SUBJECT: INCREASE OF THE SPENT FUEL POOL STORAGE CAPACITY

Re: R. E. Ginna Nuclear Power Plant

Amendment No. 65
License No. DPR-18

SAFETY EVALUATION
BY THE OFFICE OF NUCLEAR REACTOR REGULATION
SUPPORTING AMENDMENT NO. 65 TO
PROVISIONAL OPERATING LICENSE NO. DPR-18
ROCHESTER GAS AND ELECTRIC CORPORATION
R. E. GINNA NUCLEAR POWER PLANT
DOCKET NO. 50-244

Figure 1. Pool Layout

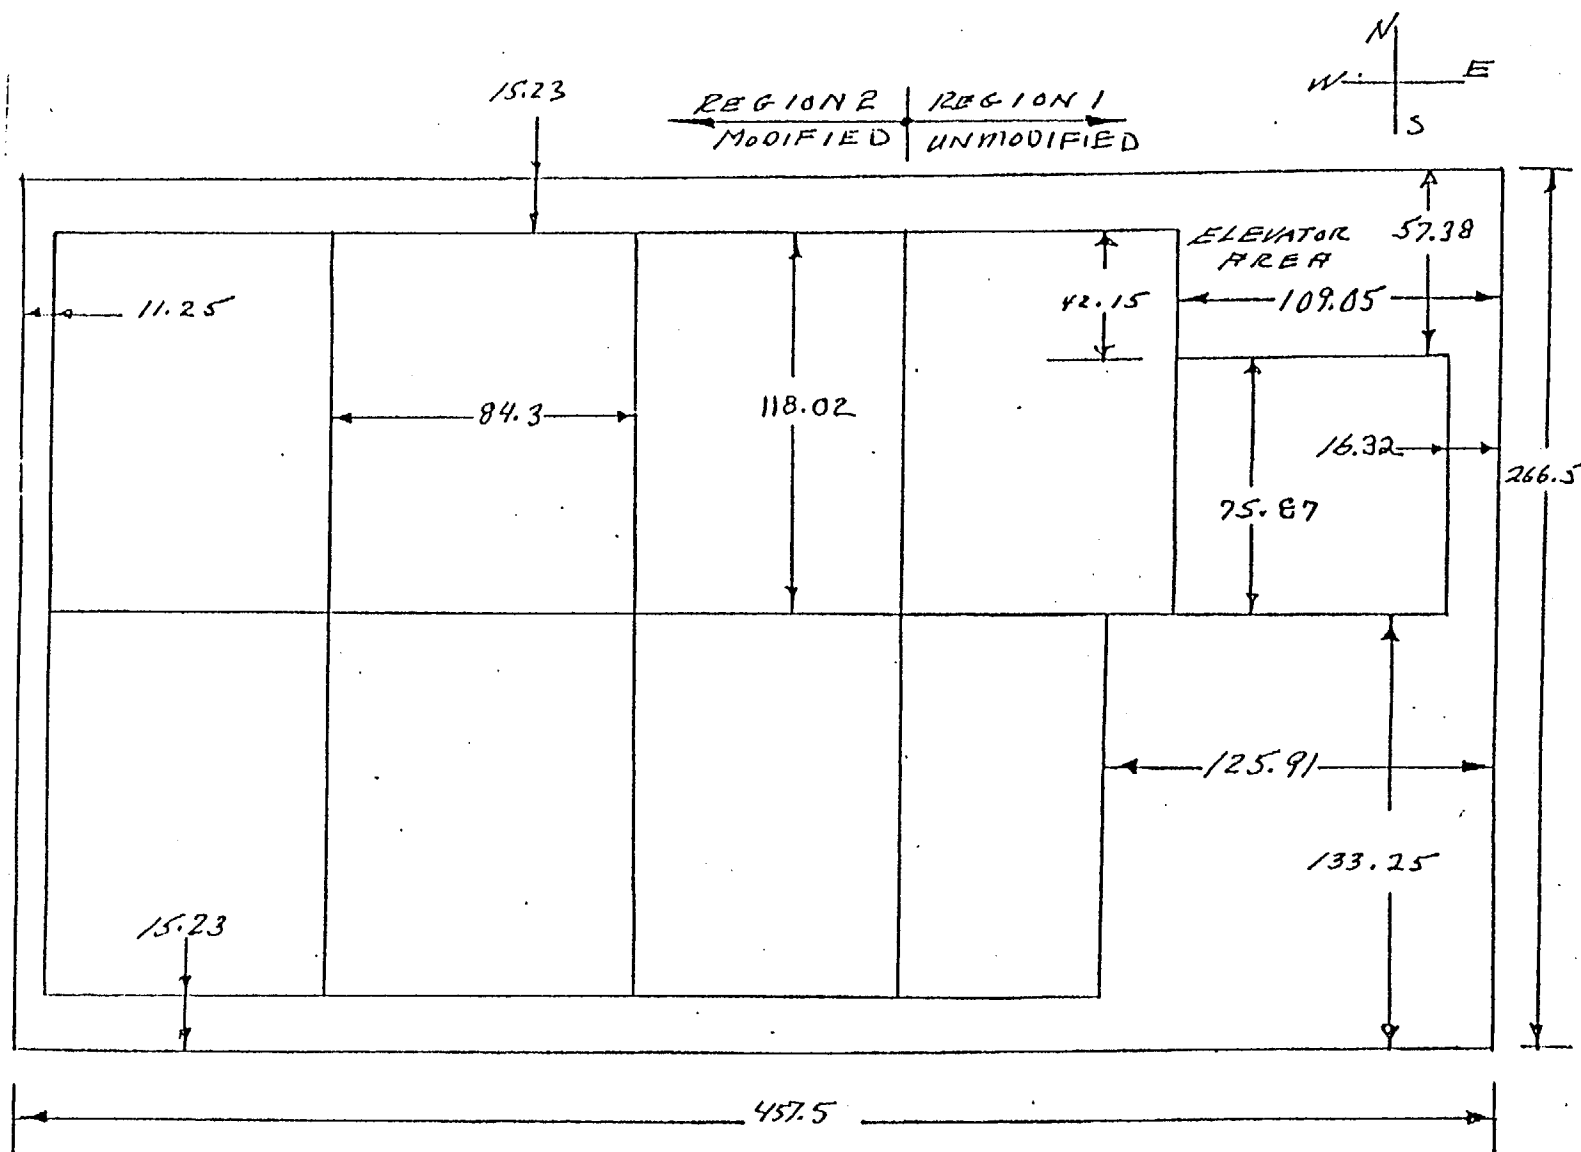
Only the six modules in Region 2, shown in Figure 1, are subjected to rerack modification [1]. All of these modules have identical cross-sectional dimensions, 84.3 in x 118.02 in. Modules having this design of nearly square cross sections generally behave in three-dimensional fashion in seismic events. Hence, the modules will exhibit three-dimensional nonlinear structural behavior under earthquake loadings, and all seismic analyses of modules should therefore focus on characterizing this behavior.

The pool layout shown in Figure 1 indicated that there is no gap between adjacent modules in the pool. The Licensee stated that, because of the strong hydrodynamic coupling effects in the case of no gap, adjacent modules were forced to vibrate in phase, thus precluding any impact between adjacent

The Licensee responded [5] by performing an impact analysis. The RACKOE model shown in Figure 2 was modified to include the compression-only springs at the top of the module to represent the presence of the adjacent module. The compressive force obtained in these springs was used to calculate the impact area on the wall of fuel cells based on the allowable compressive stress requirement. The length of wall required to resist the compressive force was calculated to be 16.0 inches in the east-west direction and 16.9 inches in the north-south direction. These impact wall lengths are acceptable since there is not much space between adjacent modules. The Licensee also demonstrated that the impact between adjacent modules would not adversely affect the stress distribution within the module structure [6].

Figure 2. RACKOE Model of Spent Fuel Racks

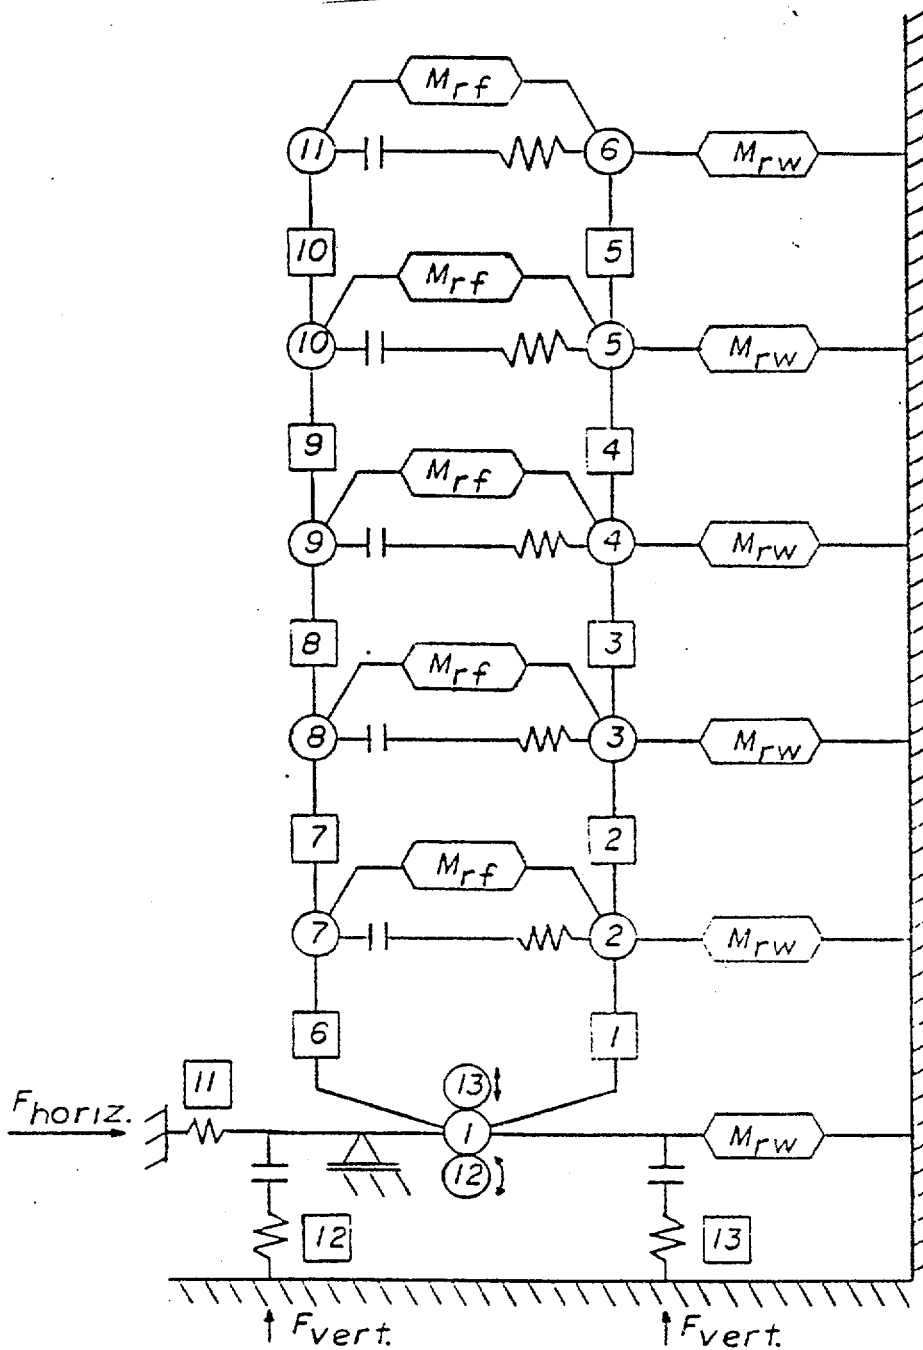
A two-dimensional nonlinear model was developed in accordance with the special purpose finite element program, RACKOE. This program was designed to solve the equations of motion explicitly using Euler's extrapolation formula. A schematic view of the RACKOE model is shown in Figure 2.

The assumption in Item c may be valid when adjacent modules are identically loaded, but an out-of-phase response will most likely occur for differently loaded modules, either empty, partially, or fully loaded.

Figure 3. Simplified RACKOE Model for Liftoff Analysis

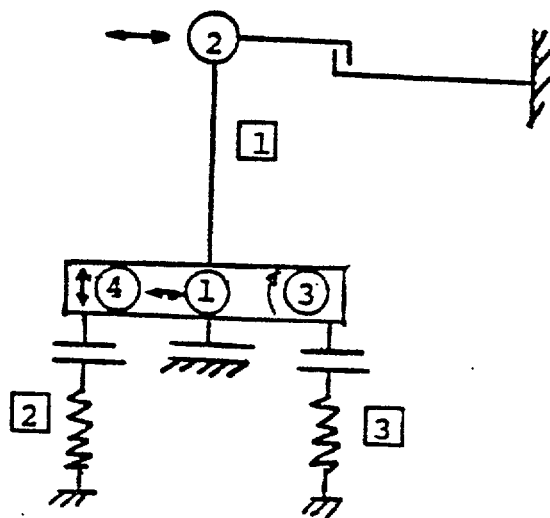
structure. A modified RACKOE model, shown in Figure 3, was used in this analysis [8]. This simplified model used a single mass to simulate the module and its contents. This approach basically assumes a stiff beam to represent the entire module. This assumption is reasonably valid because the module is very stiff in the vertical direction. Furthermore, the Licensee demonstrated that identical results were obtained from a model containing five concentrated mass nodes to represent the module structure and its contents [6].

For the operating life of the plant, the Licensee predicted that the maximum distance that the modules can slide is 0.95 in [4]. The closest obstruction, excluding adjacent modules, is the west wall which has an installed gap of 11.25 in. Consequently, the module sliding and tilting will not impact the pool wall. Since there is no gap between adjacent modules, this predicted sliding of modules will probably cause some form of impact between adjacent modules. As discussed in Section 3.2.3, an impact analysis was performed to insure that no damage was caused by the impact to the module structure and its contents.
